Moser Pass At Denali Final Development Plan

REQUEST: The applicant is seeking approval of final development plan and final plat by demonstrating compliance with all conditions of approval that are specifically required. This submittal specifically addresses the incompleteness items included in the October 24, 2023, incompleteness letter.

II. INCOMPLETENESS LETTER ITEMS

PARK EXHIBIT

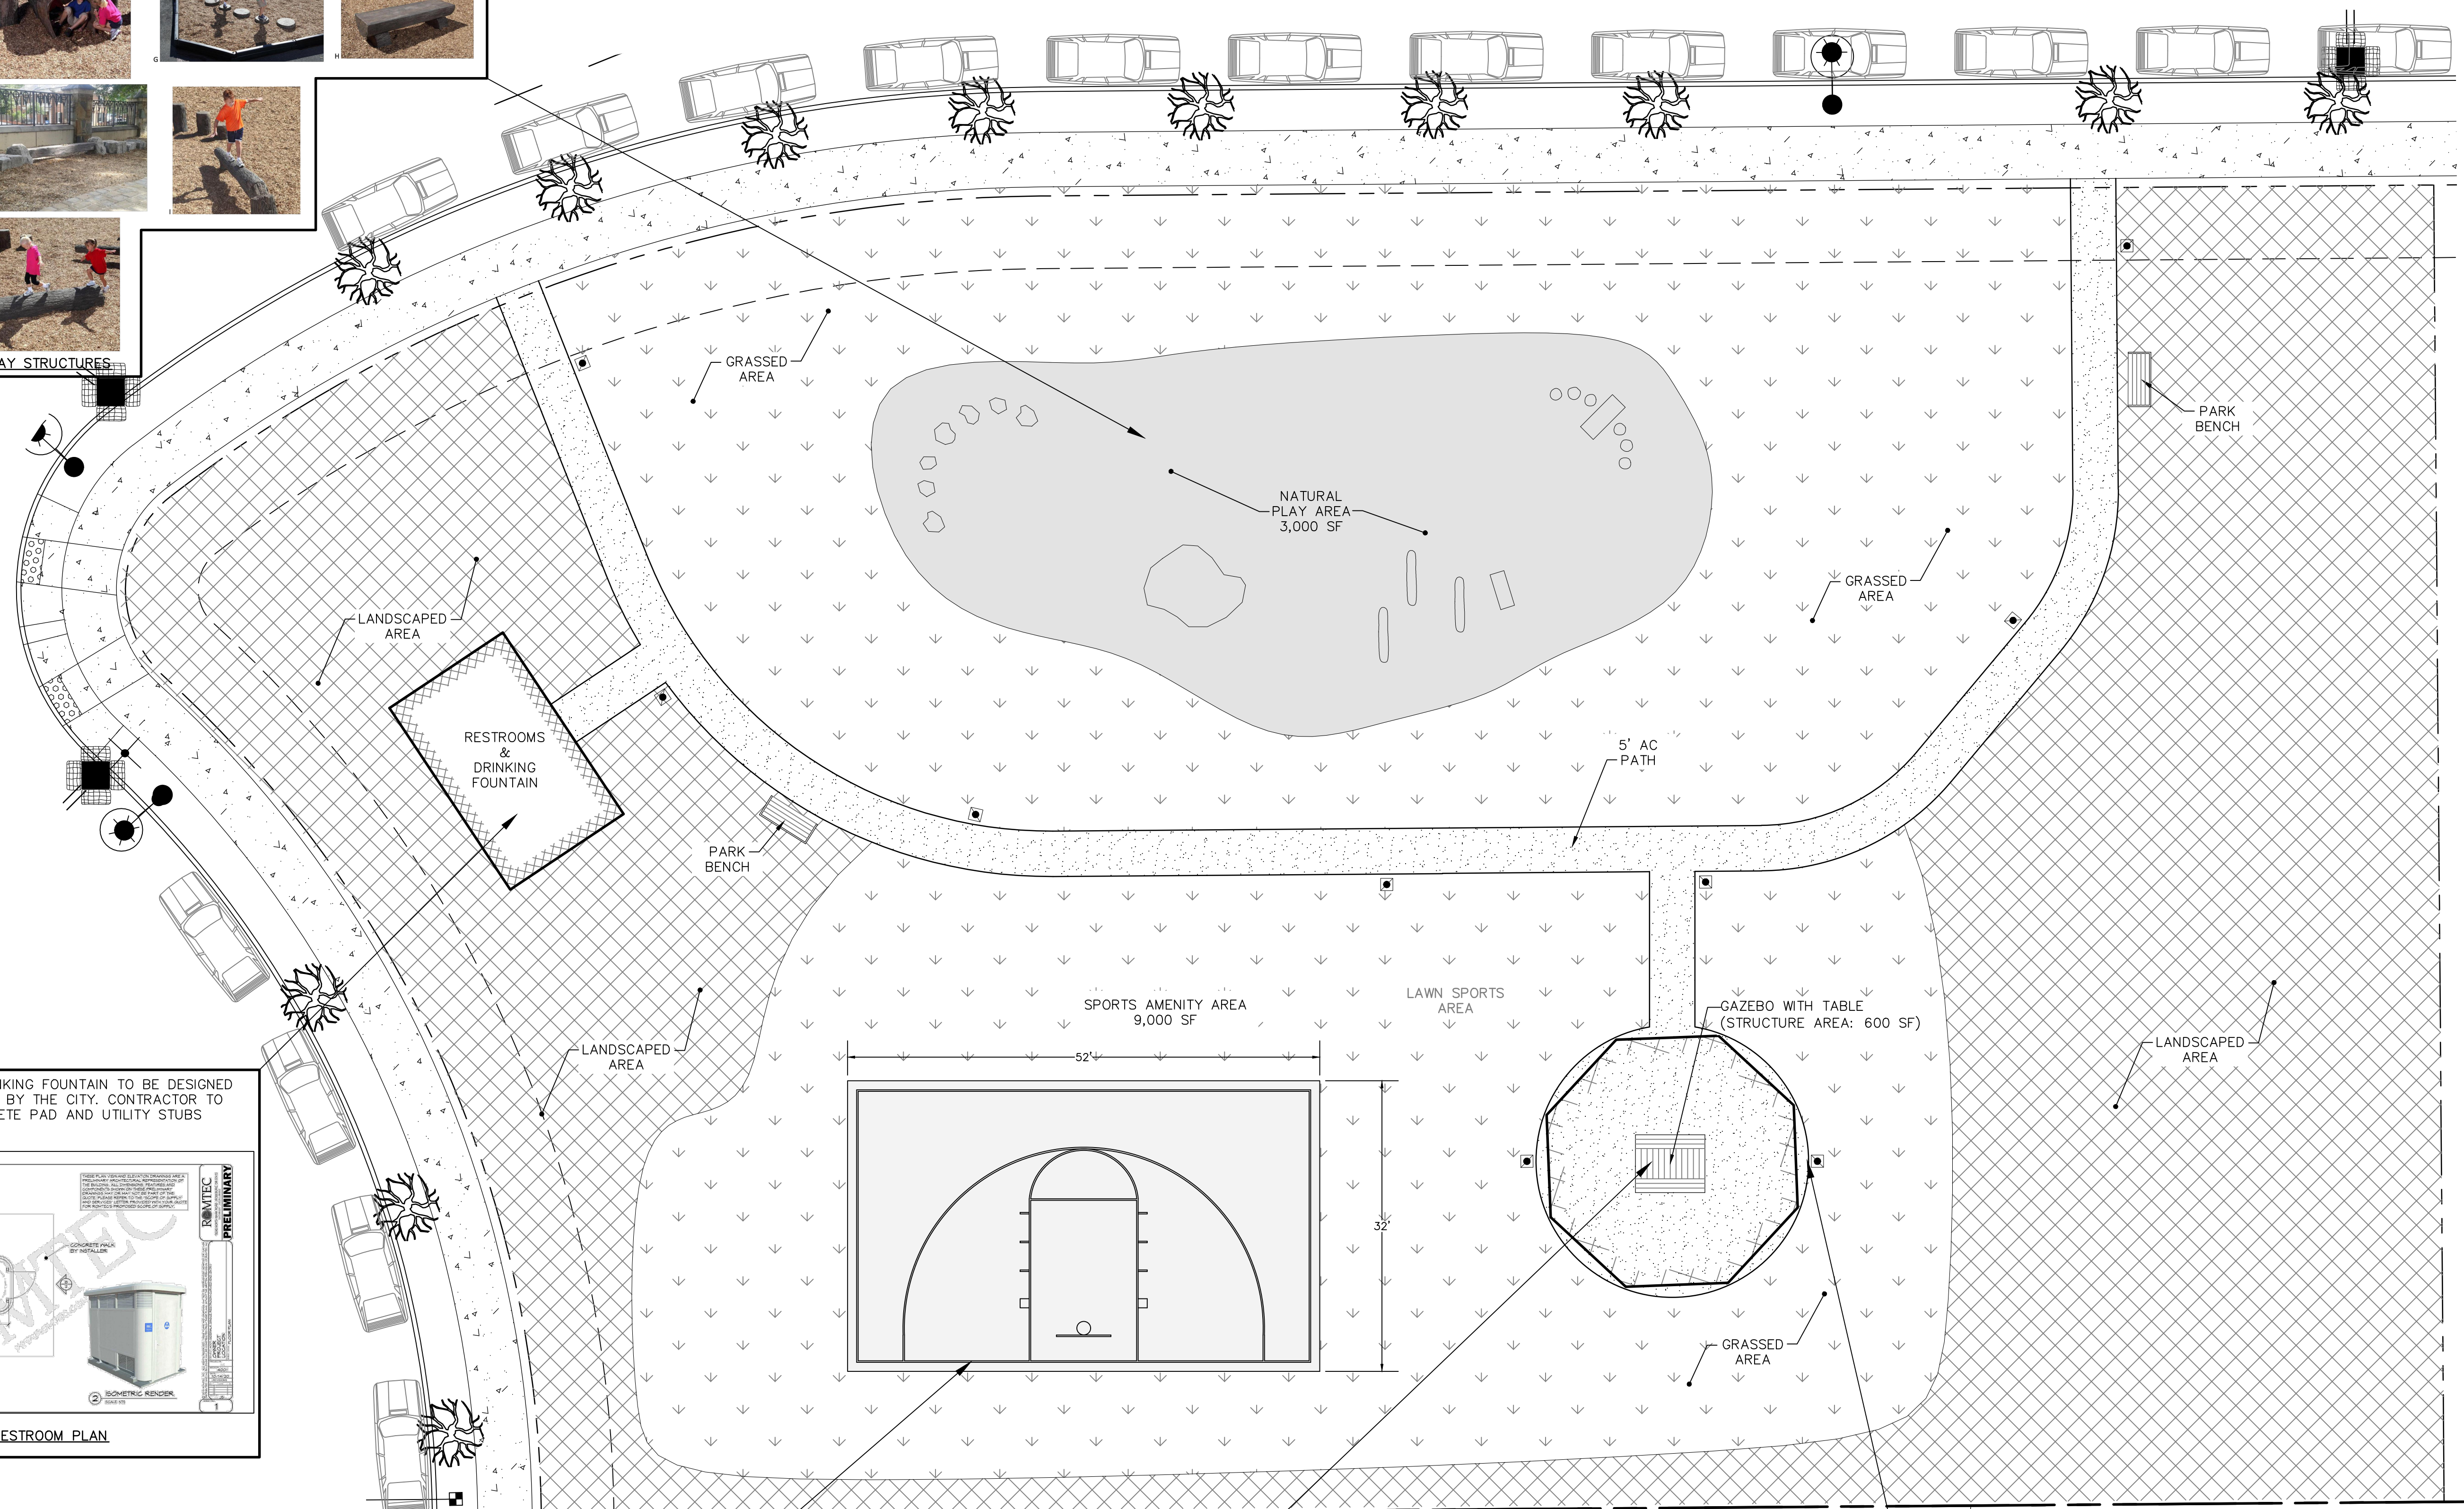
Submit a lighting plan.

Per the Sherwood's Parks Master Plan, the proposed bocce ball court and horseshoe pits are not considered sports courts. Examples of sports court are tennis, basketball, pickleball, and volleyball courts.

The gazebo needs to be a minimum of 600 SF. Please modify the plans to reflect a gazebo or other covered structure meeting the minimum of 600 SF.

See attached details for the restrooms. Coordination with Sherwood Public Works will need to be ongoing.

Applicant Response: The lighting shown on the park plan exhibit (Exhibit D) is consistent with the submitted lighting plan to address the comment above. The applicant has removed the bocce ball court and horseshoe pits from the plan and has replaced those facilities with a basketball court to meet the desire of the City. The gazebo is shown to have an 'interior' area of 600 sf, includes a picnic table and lighting (lighting also reflected in the submitted lighting plan). The restroom detail has been added for reference and remaining Public Works conditions are ongoing.

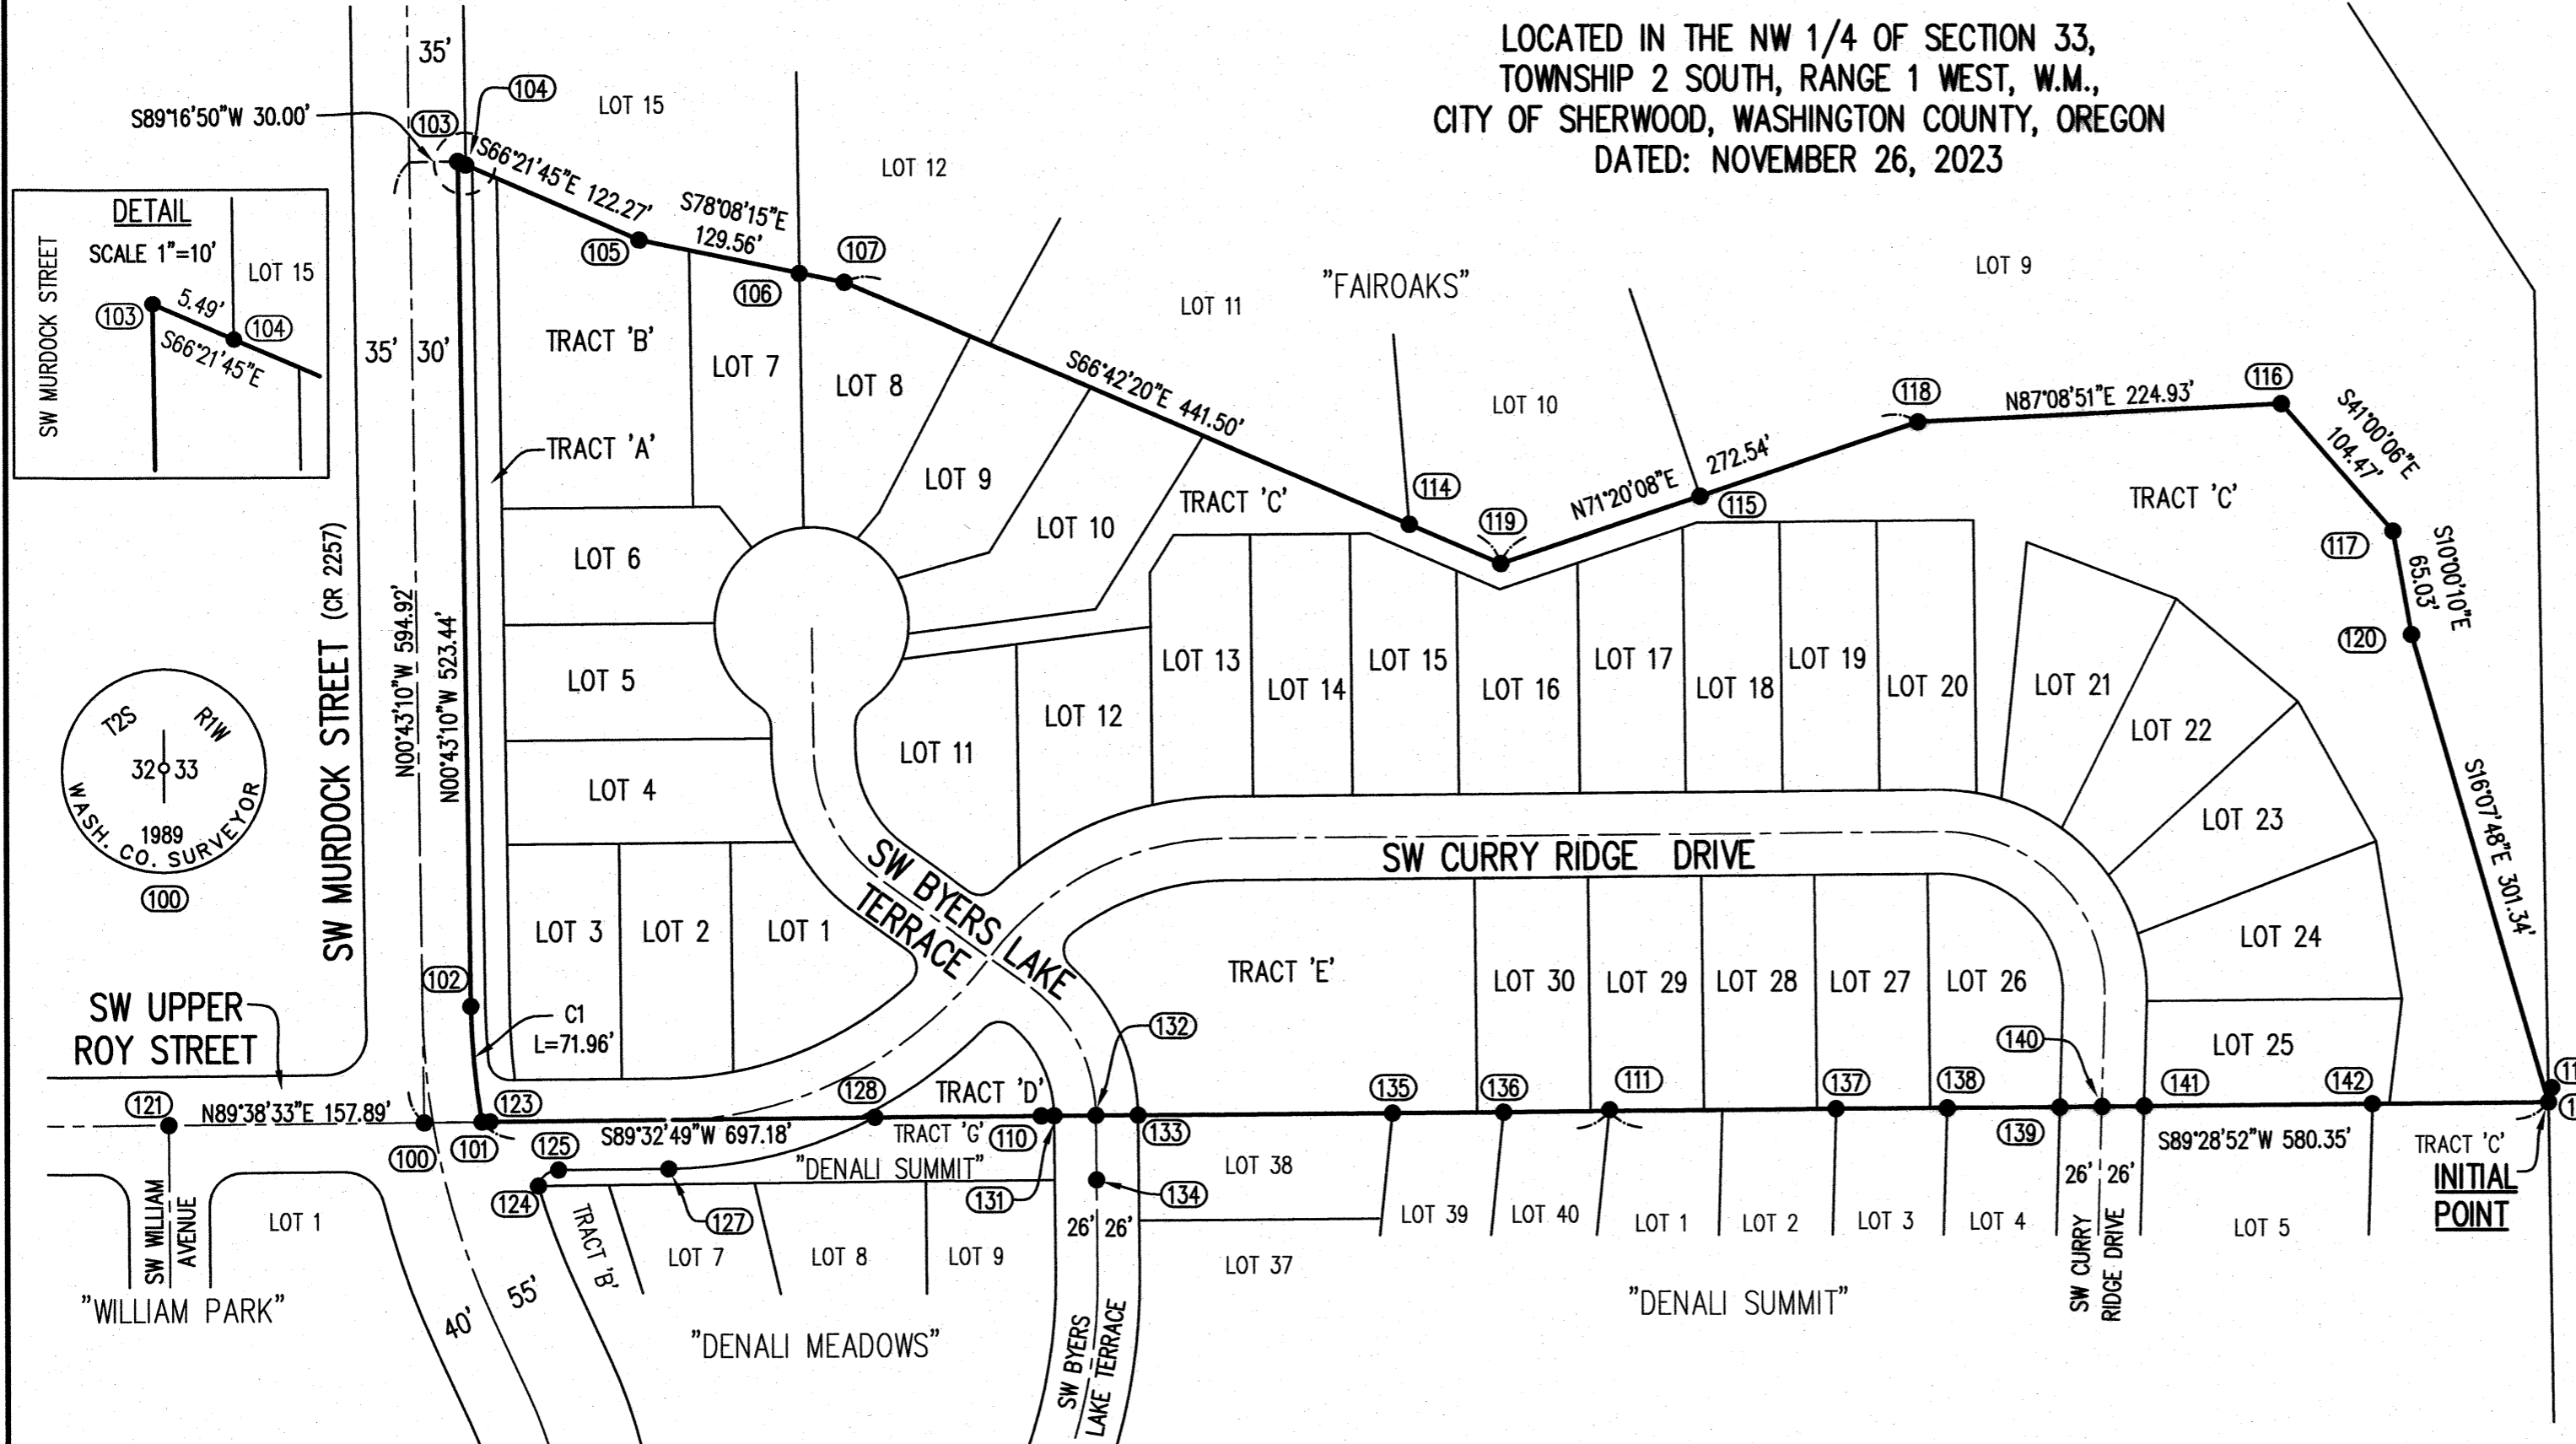
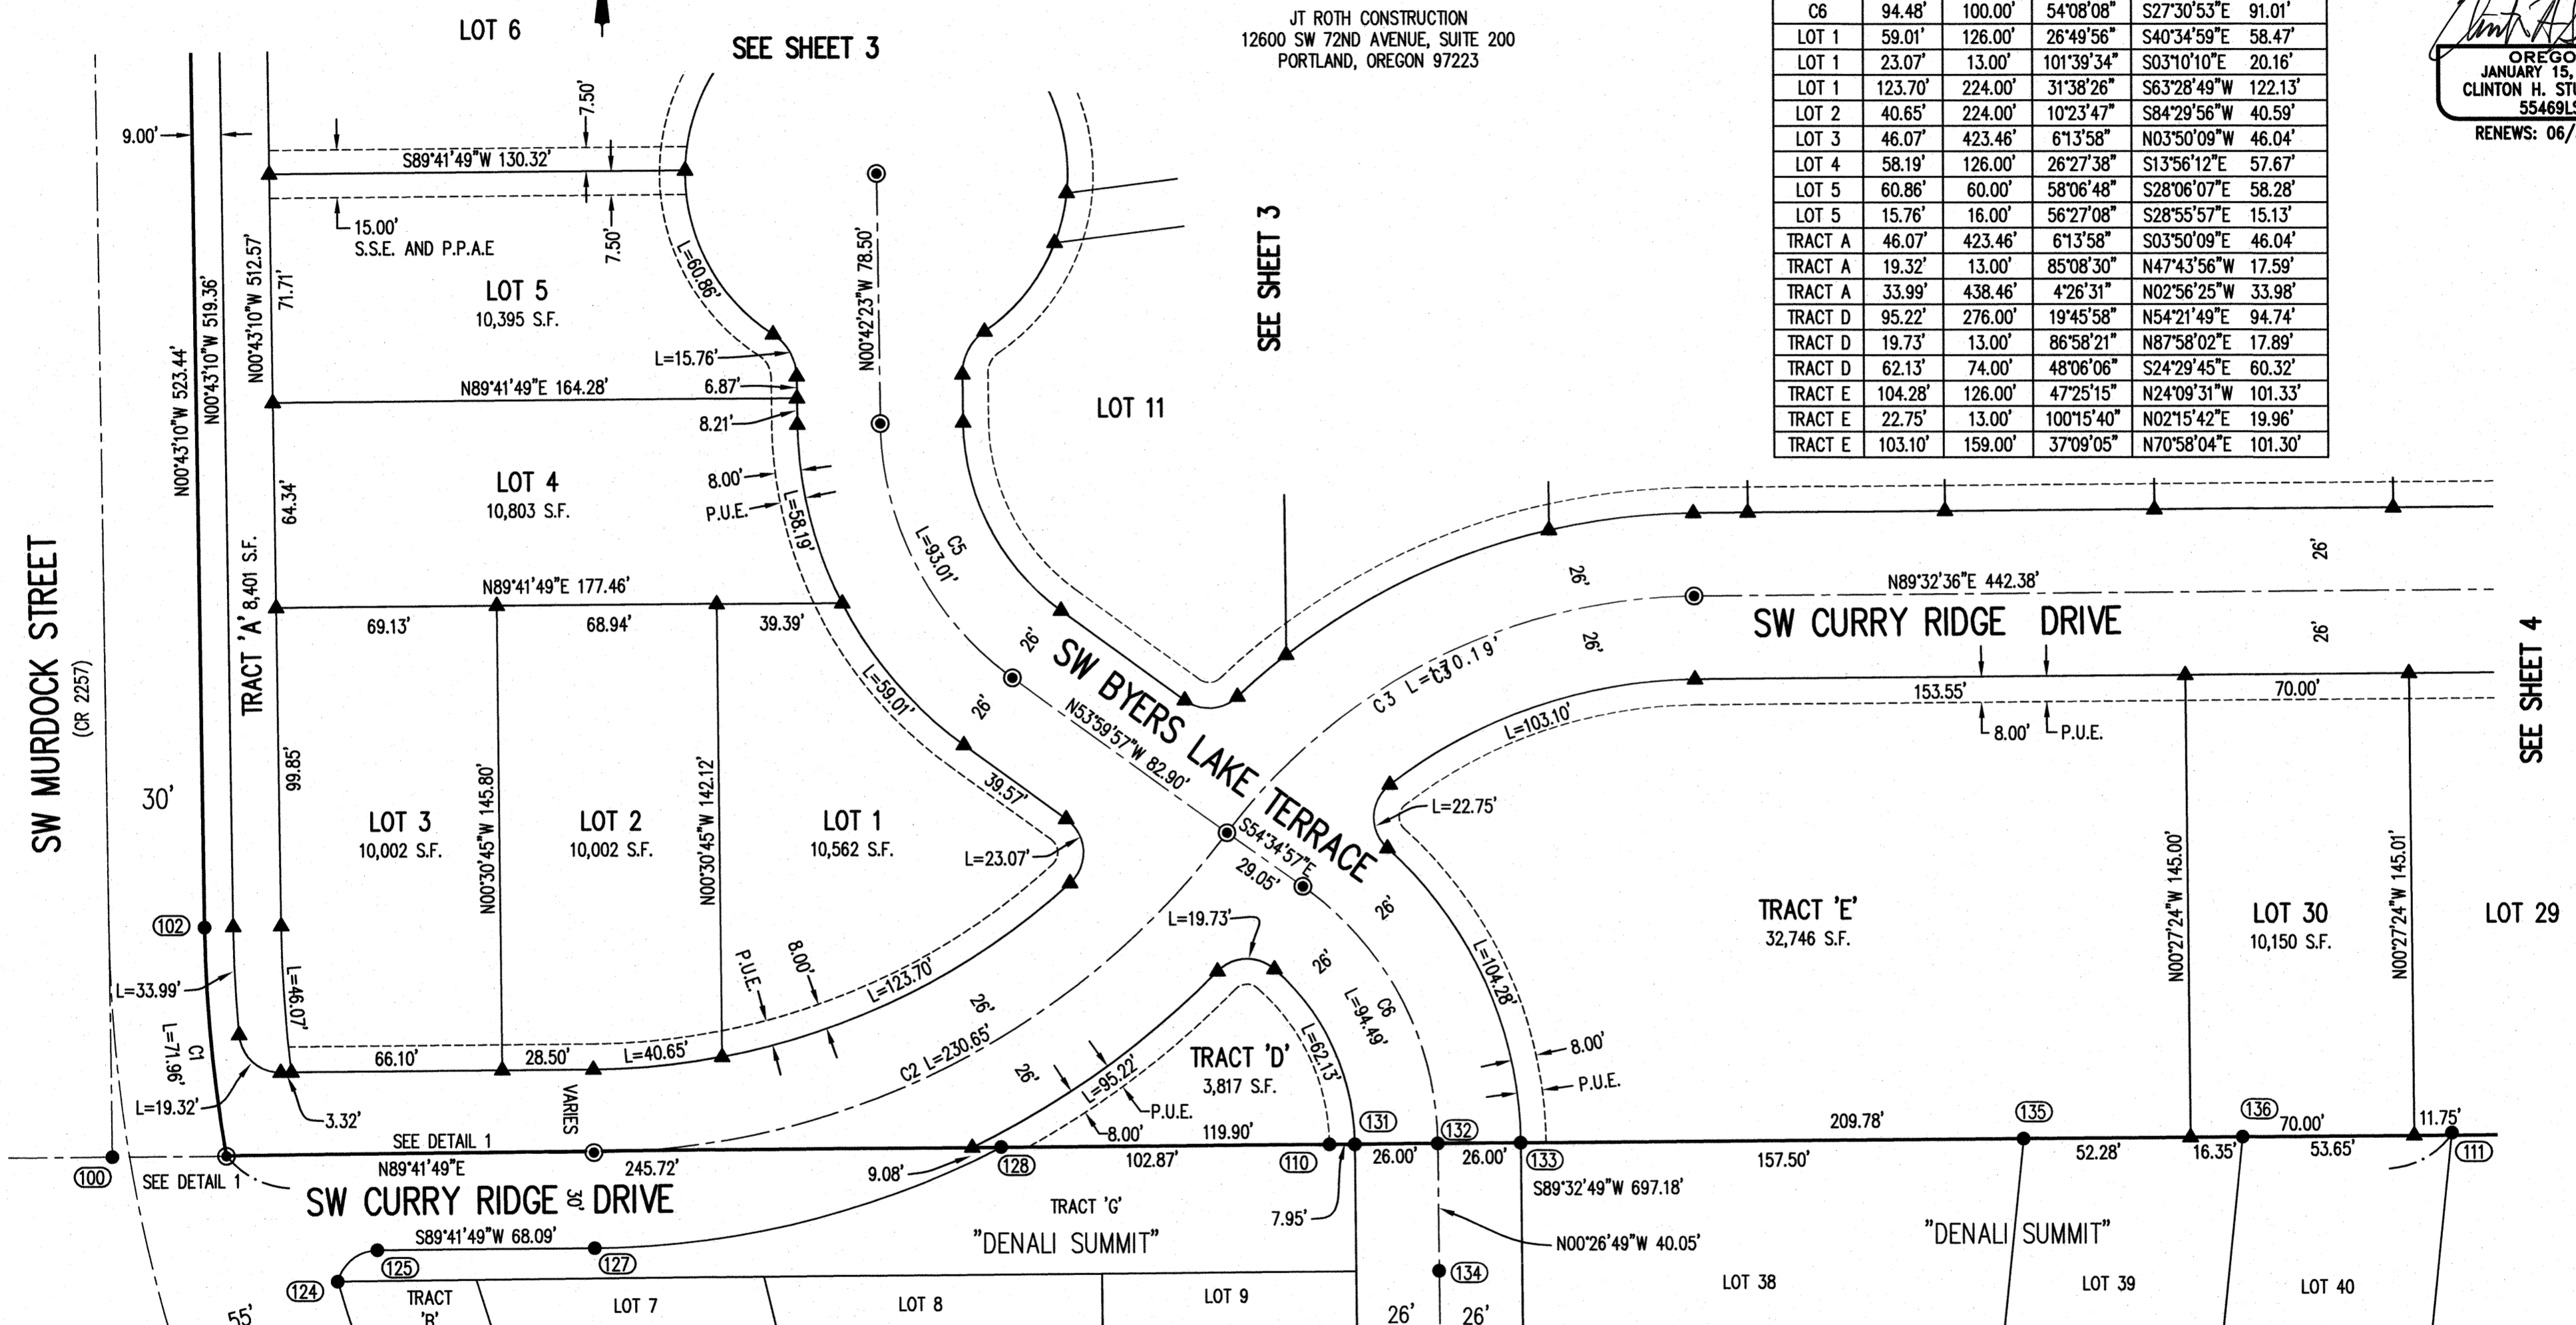
- 1. Sherwood Engineering Department reviewed the plat stating that necessary easements for city utilities need to match the submitted engineering plans (see attached). The Plat should also label all the Open Space Tracts (Tract C and Tract D missing labels).**
- 2. Plat Declaration Page and Plat Notes needs to be submitted.**
- 3. The application identified the plat as “Tentative”. Please submit the latest with the above requested changes.**

Applicant Response: A final plat prepared by a licensed surveyor has been included with this submittal. The submitted plat labels all tracts, easements and ‘Tentative’ have been removed.
